U S NAVY RESPONSE TO REGULATOR COMMENTS TO DRAFT FINAL SAMPLING AND  
ANALYSIS PLAN ADDENDUM FOR PERFLOURINATED COMPOUNDS WITH TRANSMITTAL  
NAS SOUTH WEYMOUTH MA  
4/11/2011  
TETRA TECH

Subject: Responses to Comments – Draft Final Sampling and Analysis Plan Addendum  
Perfluorinated Compounds  
Naval Air Station South Weymouth, Weymouth, Massachusetts

**NAVY RESPONSES TO U.S. ENVIRONMENTAL PROTECTION AGENCY (EPA)  
COMMENTS (DATED MARCH 28, 2011)  
DRAFT FINAL SAMPLING AND ANALYSIS PLAN ADDENDUM  
PERFLUORINATED COMPOUNDS  
NAVAL AIR STATION SOUTH WEYMOUTH, WEYMOUTH, MASSACHUSETTS**

Figure 1 – Locations of Groundwater and Soil Samples Near Crash Truck Garage

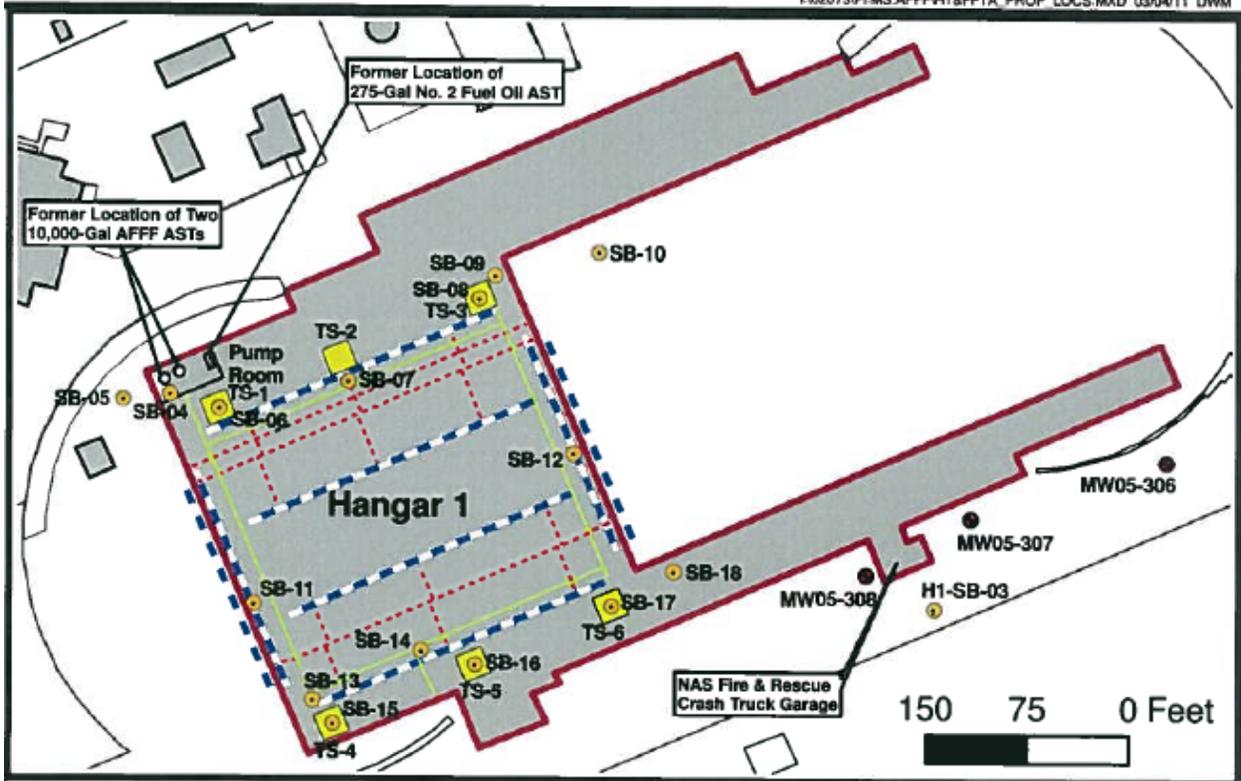
**17. Page 38 of 54, SAP Addendum Worksheet #14 -- Sampling Locations and Methods** - Please see General Comments 1. and 2., above, concerning conceptual site model (CSM) and Ground Water, Surface Water, and Sediment Sampling areas for additional recommendations regarding sampling locations and media. A number of additional recommendations are as follows:

- ❖ *The soil sampling locations relative to Hangar 1 appear to be justified. However, as mentioned in the General Comments, it is difficult to comprehensively evaluate the locations because the site plan has not been updated with all of the subsurface utilities. For example, how were the OWS units connected to the base subsurface drainage system? How was the Hangar 1 drainage system connected to the base-wide system? Please provide a complete subsurface utility plan. Please also indicate the location of the fill pipes for the former AFFF ASTs. Depending on the location, additional samples may be required. For example, if these were located on the building exterior, a soil boring should be located in that area.*

- ❖ *Regarding ground water sampling down-gradient of Hangar 1, the inclusion of MW09-006, MW05-034 and proposed new wells H1-MW-2/2D appear to address the majority of the issues associated with the potential “westerly pathway” (see General Comments, above, and Figure A, attached). Consideration should still be given to installing additional well control to the west of the series of existing and proposed wells. A site walkover and detailed subsurface utility plan is needed in order to confirm the adequacy of the proposed H1-MW-2/2D locations.*

**Response:** Comment noted. As previously mentioned, a site visit is planned with the regulators to review and confirm sample locations. Hangar 1 facility drawings are available for review at the CSO, NAS South Weymouth.

As stated in the Response to Comment 7, Worksheet #14 will be revised to include collection of groundwater samples from existing wells, MW05-306, -307, and -308, to assess groundwater quality southwest of the South Lean-to crash truck garage (AFFF storage area). In addition, soil samples will be collected from borings adjacent to MW05-307 and -308, and also from a boring in the vicinity of the crash truck garage (see Figure 1).
